TECHNICAL SERVICE BULLETIN

Transmission Clutch Fluid Overheating During Track Use - Vehicles Equipped With Parallel Coolers Only

20-2223

This bulletin supersedes 18-2391. Reason for update: Incorrect Procedure

Figure 2 - Parallel

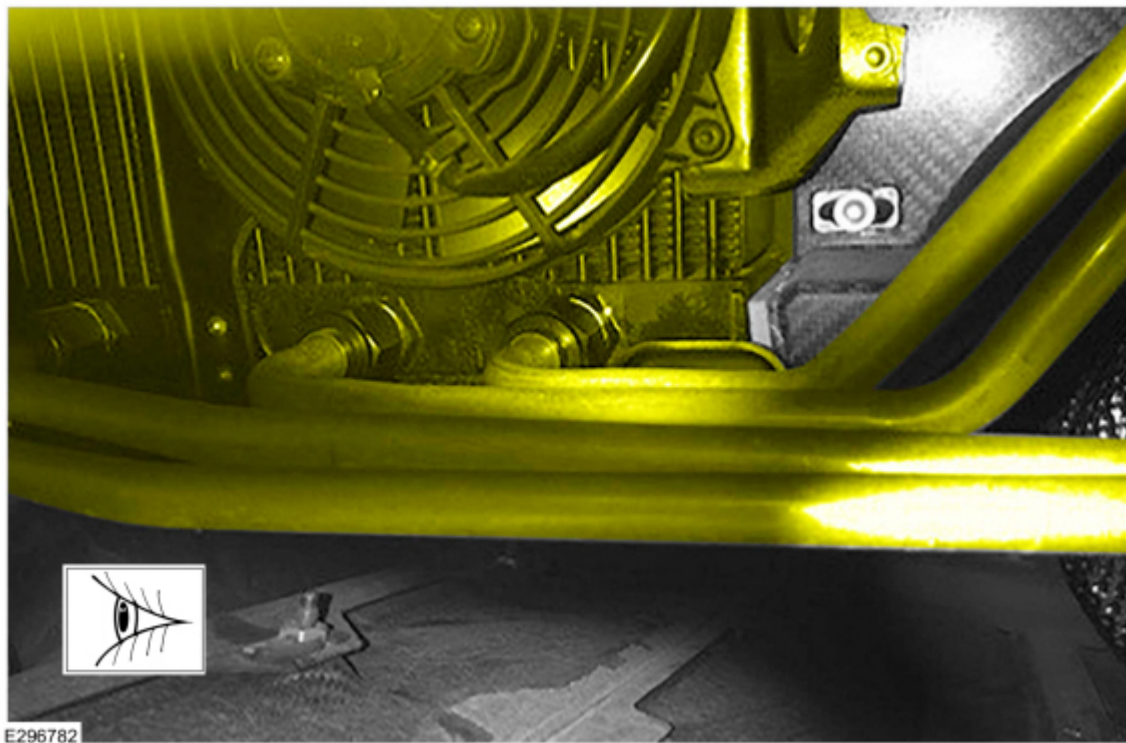
1. Inspect the factory equipped transmission gearset and clutch cooler by looking through the rear fascia grille opening at the left side of the rear bumper cover. (Figure 1) Is the vehicle equipped with a perpendicular transmission gearset and clutch cooler? (Figure 2-3)

(2). No - proceed to Step 2.
